RE: SUBMISSION TO SSI-10038 – SYDNEY METRO WEST

This submission has been prepared by Urbis Pty Ltd (**Urbis**) on behalf of Mayrin Group in respect of a State Significant Infrastructure (**SSI**) application (SSI-10038) for Sydney Metro West Environmental Impact Statement – Concept and Stage 1 (**the project**). The Environmental Impact Statement (**EIS**) and associated documents for the project were placed on public exhibition on 30 April 2020.

Figure 6 Proposed protective underground corridor location

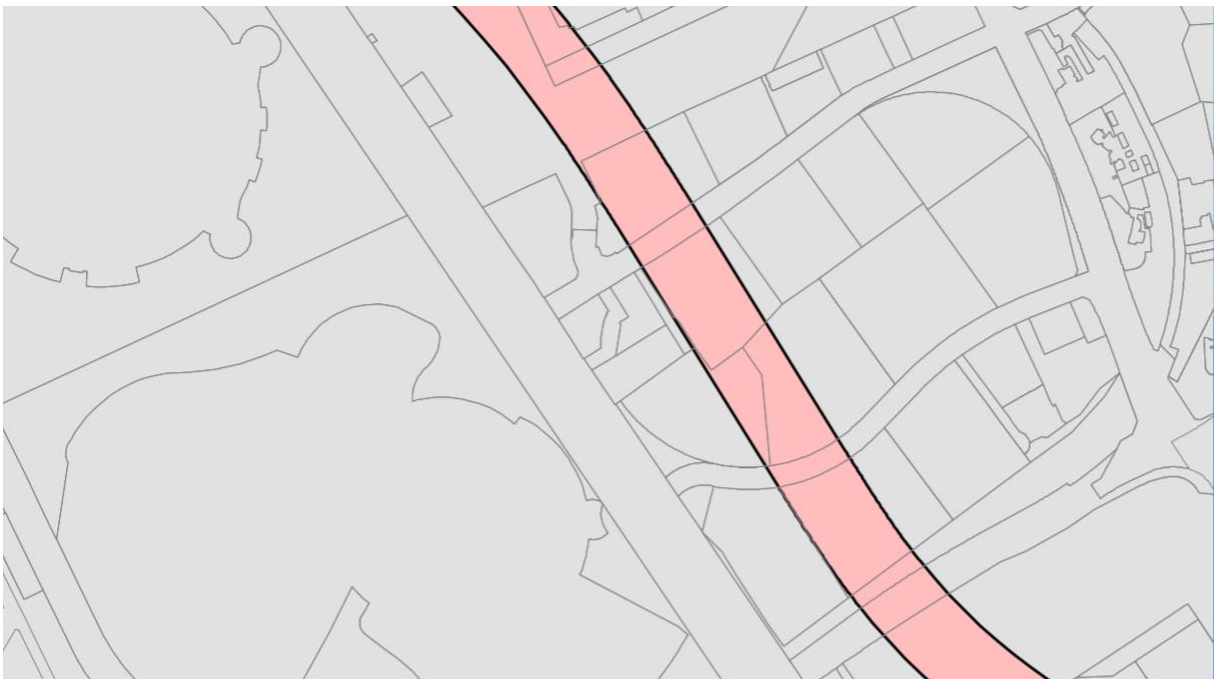
Concurrent with the EIS, the DPIE exhibited draft amendments to the *State Environmental Planning Policy (Infrastructure) 2007 (Infrastructure SEPP)* to create a new short-term “protective” underground corridor related to the proposed alignment of the Sydney Metro West. The proposed amendments were on exhibition from 30 April 2020 until 26 April 2020. All feedback and submissions are now under consideration.

The location of the protective corridor in relation to the site is illustrated in **Figure 6**.

The SEPP amendment will allow for the preservation of the substratum transport corridor, which will be acquired by Sydney Metro once planning approval is received. The SEPP amendments aim to amend Clause 88 – Development within or adjacent to interim rail corridor to “*ensure that development does not occur within the interim corridor that then could subsequently prevent, compromise or increase the costs of delivering the rail project within the corridor*”.

Mayrin Group acknowledges and notes the future development on the site will require notification and concurrence from Sydney Metro.
